MOD1 - Main Access Tunnel to Marica Services Connection

Submissions Report

Prepared for Snowy Hydro Limited
December 2021

E210745 RP#2

Marica Services Connection –
Heritage Survey Units

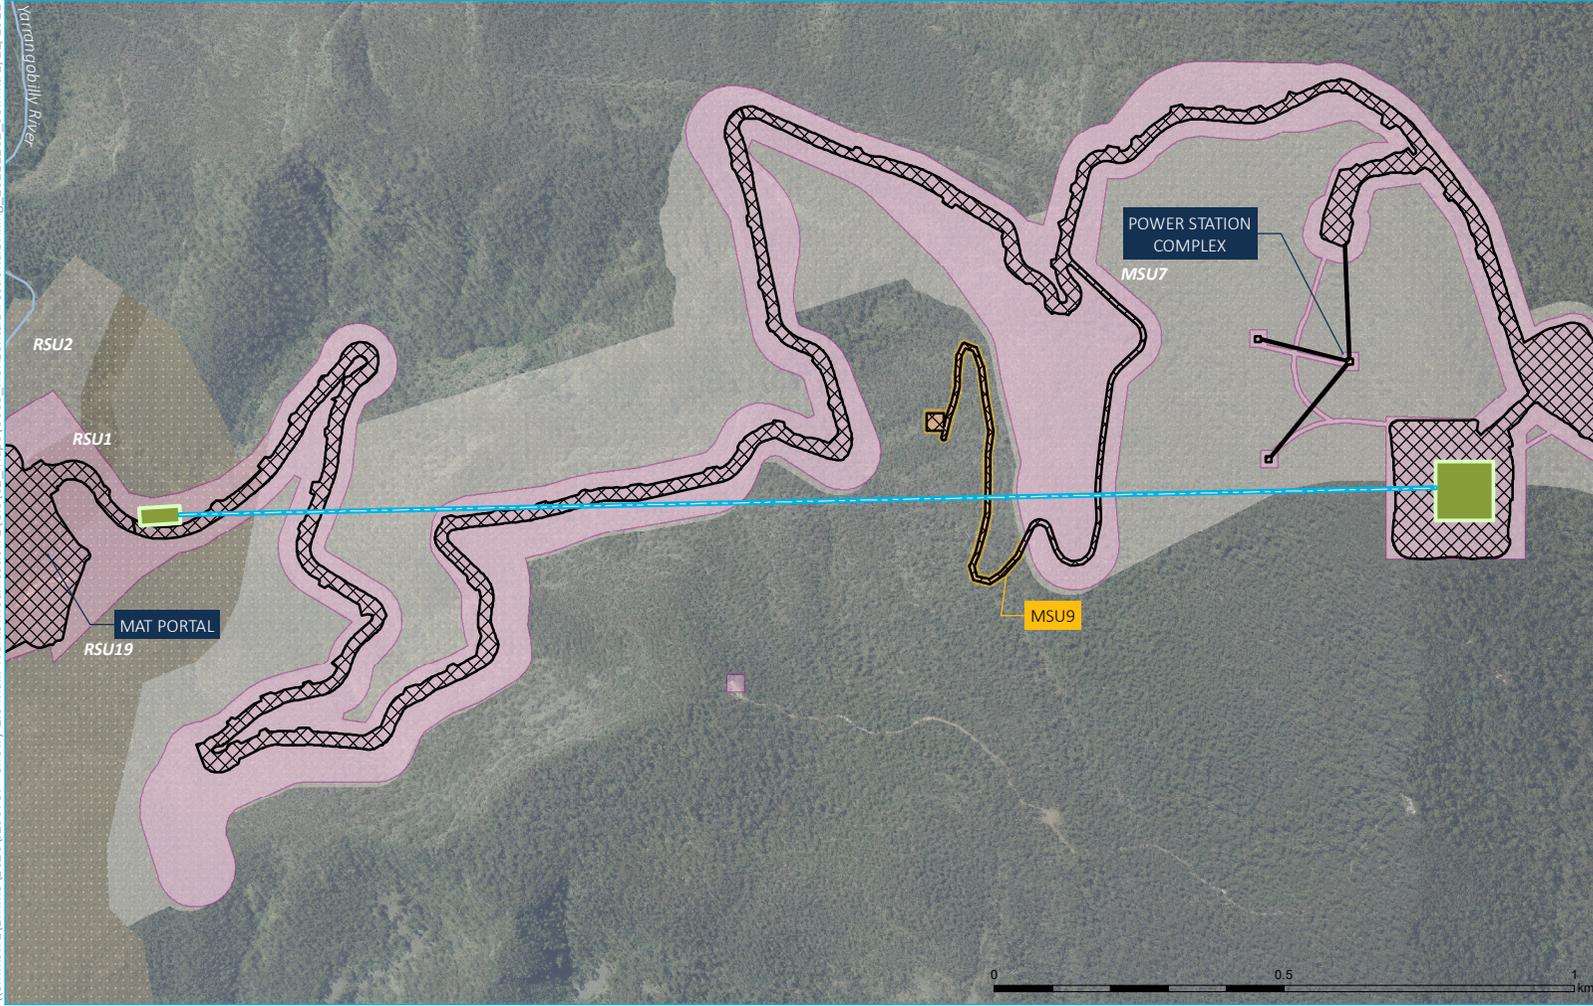
Heritage NSW commented that as one of the survey units within the proposed modification area, MSU9, was identified as un-surveyed during the original Main Works EIS, it recommended that the proponent is satisfied that no unnecessary impacts will occur to Aboriginal objects or cultural values because of the modification.

Heritage NSW supports the approved Heritage Management Plan continuing to apply to the proposed modification works, and asked for the plan to be reviewed and updated so that the new boundaries of works are consistent with the proposed modification changes. It also asked to be supplied with the results of salvage excavations for the project.

The proposed modification is highly unlikely to affect cultural heritage sites. The heritage survey unit MSU9 has not been previously surveyed, for the fact that it would not be subject to ground disturbance. This will still be the case for the proposed modification, which will involve drilling up to 7 holes with diameter up to 450 mm at around 50-100 m below MSU9. The minor extent of the proposed drilling is highly unlikely to result in any effects at the surface and therefore MSU9 will continue to be protected from any impacts. All surface works proposed as part of the modification will occur within areas that have been assessed and approved for ground disturbance within the project construction envelope. The location of the works and heritage survey unit MSU9 are shown in Figure 4.1.

The proposed HDD works involve surface impacts only within areas that are within the approved project construction envelope where the potential for ground disturbance has already been considered and approved under the EIS and existing *Heritage Management Plan* (FGJV, 2020).
